**SUBJECT: DEMONSTRATION / DELIVERY HOLD – Compliance Recall 15C09 –
*Supplement #2***
 Certain 2011-2013 and 2015 Model Year F-650 / F-750 Vehicles with 70% Fixed Seat
 Front Passenger Fixed Seat Restraint Anchorage Point

Provide revised technical instructions for super cab vehicles.

CERTAIN 2011-2013 AND 2015 MODEL YEAR F-650 AND F-750 VEHICLES WITH 70% FIXED SEAT — FRONT PASSENGER FIXED SEAT RESTRAINT ANCHORAGE POINT

FIGURE 4

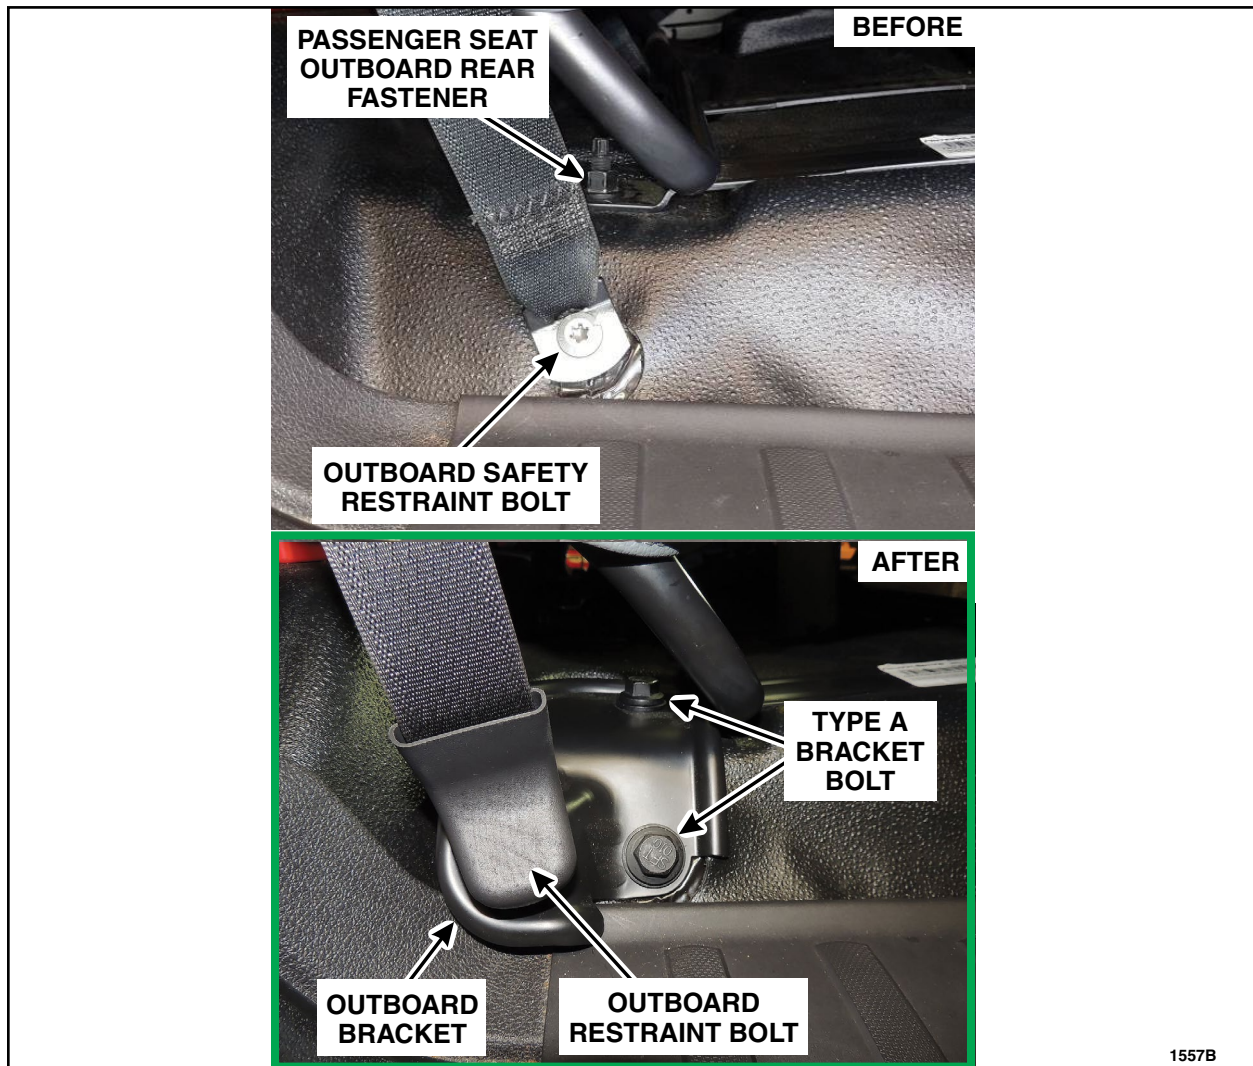
3. For all regular cab and crew cab vehicles, install the outboard bracket (See Figure 4). For all super cab vehicles, proceed to Step 4; the outboard bracket will not be used.

- a. Remove and discard the outboard safety restraint bolt and the passenger seat outboard rear fastener.

NOTE: If the passenger seat outboard rear fastener is secured with a stud and nut, the stud must also be removed and discarded.

- b. Install the outboard bracket as shown with *new* bolts.
- Install a type A bracket bolt in the original restraint location and tighten to 30 lb.ft (40 Nm).
 - Install a type A bracket bolt in place of the original seat fastener and tighten to 41 lb.ft (55 Nm).

- c. Install the safety restraint and *new* outboard restraint bolt to the relocation bracket and tighten to 30 lb.ft (40 Nm).

FIGURE 5

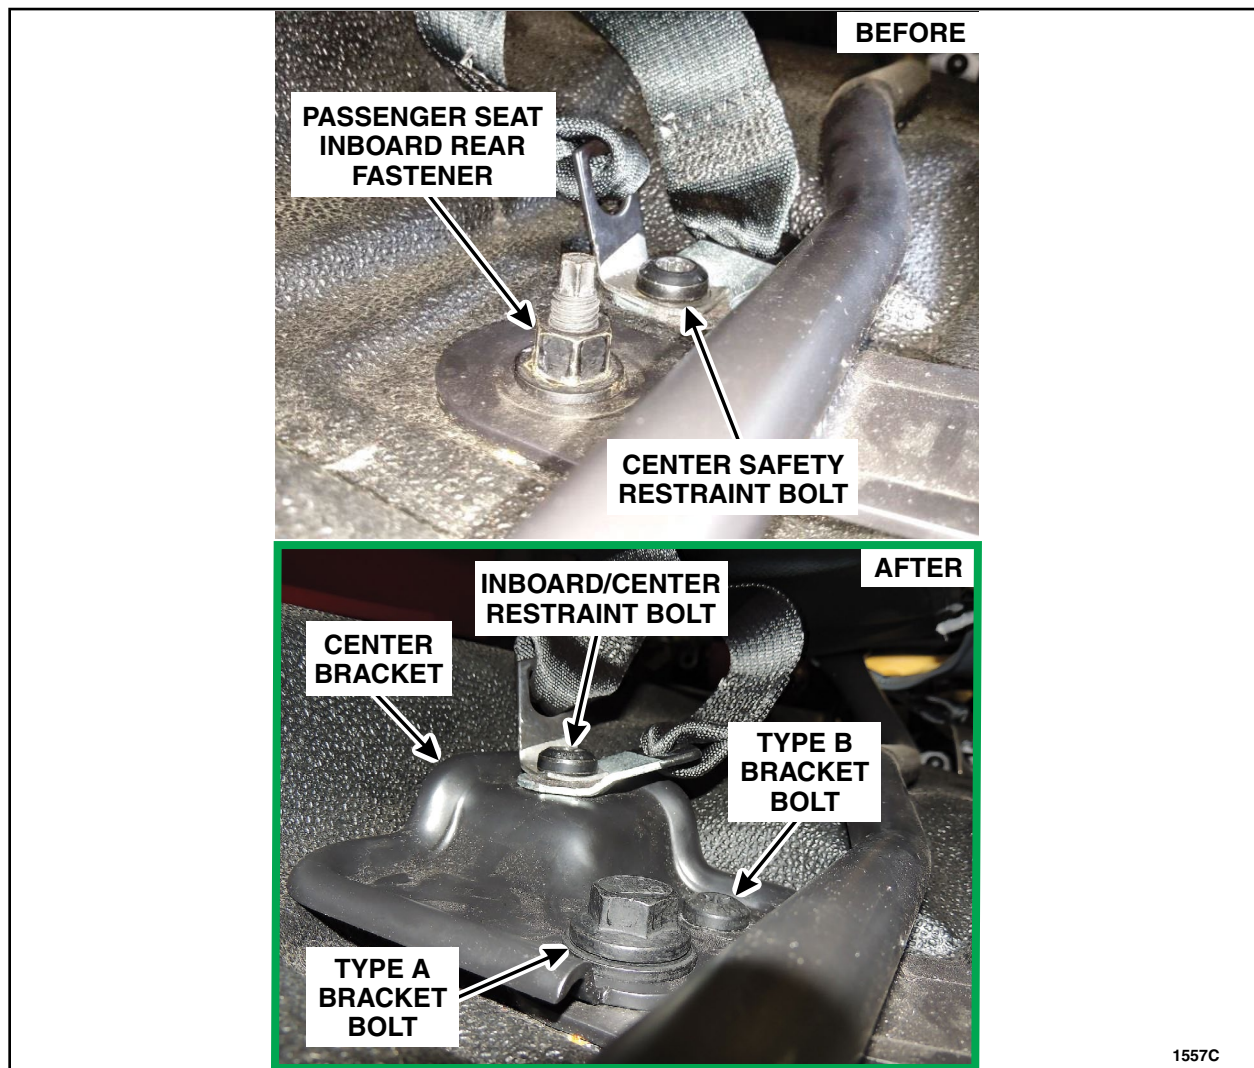
4. Install the center bracket (See Figure 5):

- a. Remove and discard the center safety restraint bolt and the passenger seat inboard rear fastener.

NOTE: If the passenger seat inboard rear fastener is secured with a stud and nut, the stud must also be removed and discarded.

- b. Install the center bracket as shown with a *new* type B bracket bolt in the original restraint location, and a *new* type A bracket bolt in place of the original seat fastener. Tighten both bolts to 41 lb.ft (55 Nm).

- c. Install both safety restraints and *new* inboard/center restraint bolt to the center bracket and tighten to 41 lb.ft (55 Nm).

FIGURE 6

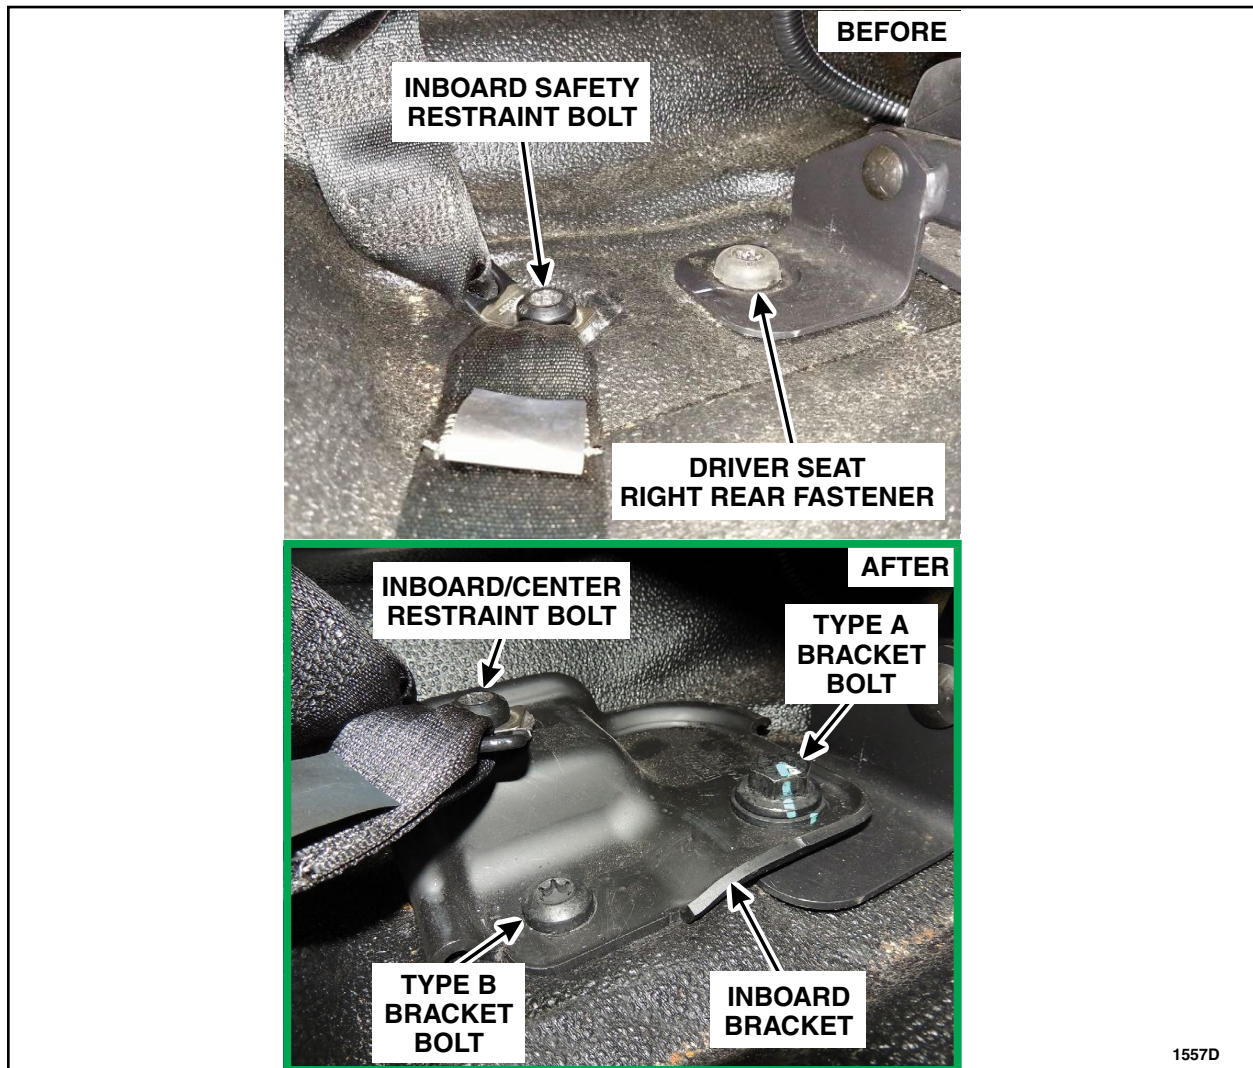
5. Install the inboard bracket (See Figure 6):

a. Remove and discard the inboard safety restraint bolt and the driver seat right rear fastener.

NOTE: If the driver seat right rear fastener is secured with a stud and nut, the stud must also be removed and discarded.

b. Install the inboard bracket as shown with *new* bolts.

- Install a type B bracket bolt in the original restraint location and tighten to 30 lb.ft (40 Nm).
- Install a type A bracket bolt in place of the original seat fastener and tighten to 41 lb.ft (55 Nm).

c. Install the safety restraint and *new* inboard/center restraint bolt to the relocation bracket and tighten to 30 lb.ft (40 Nm).
